ORMS - SK302
COMMONWEALTH HOUSE -
CYCLE STORE
CONSTRAINTS MARKUP

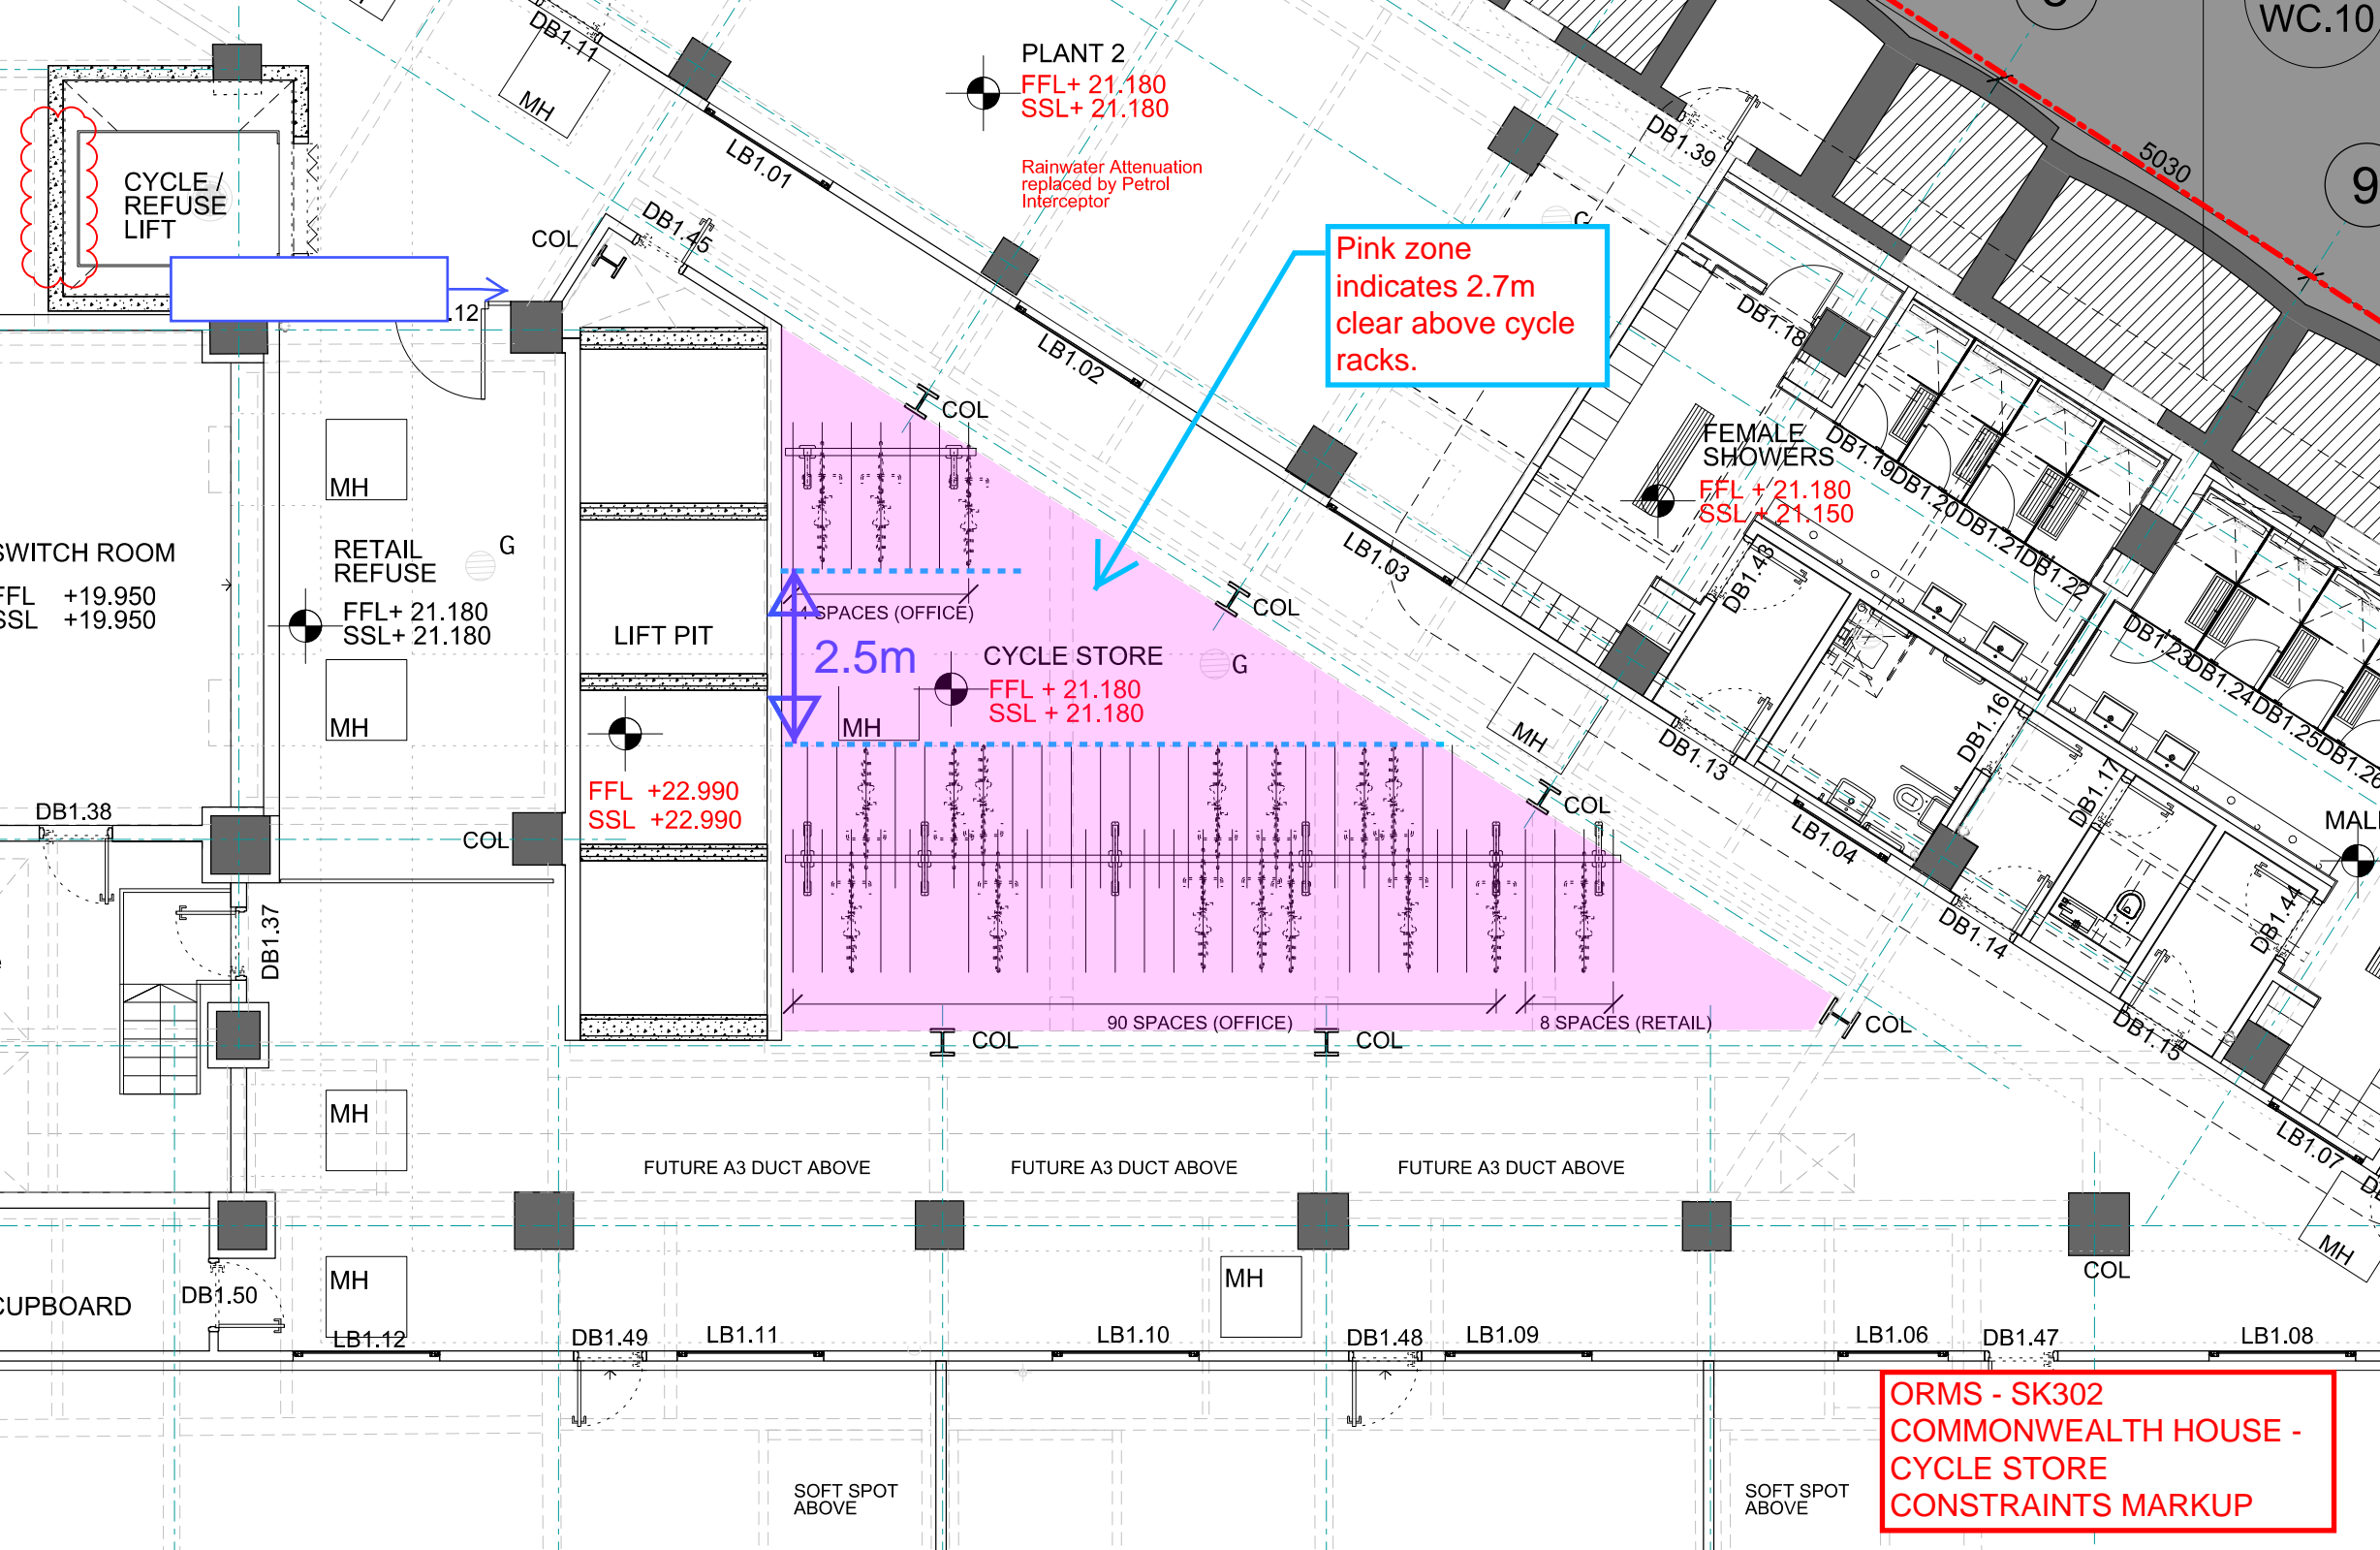
Rainwater Attenuation
replaced by Petrol
Interceptor

Pink zone
indicates 2.7m
clear above cycle
racks.
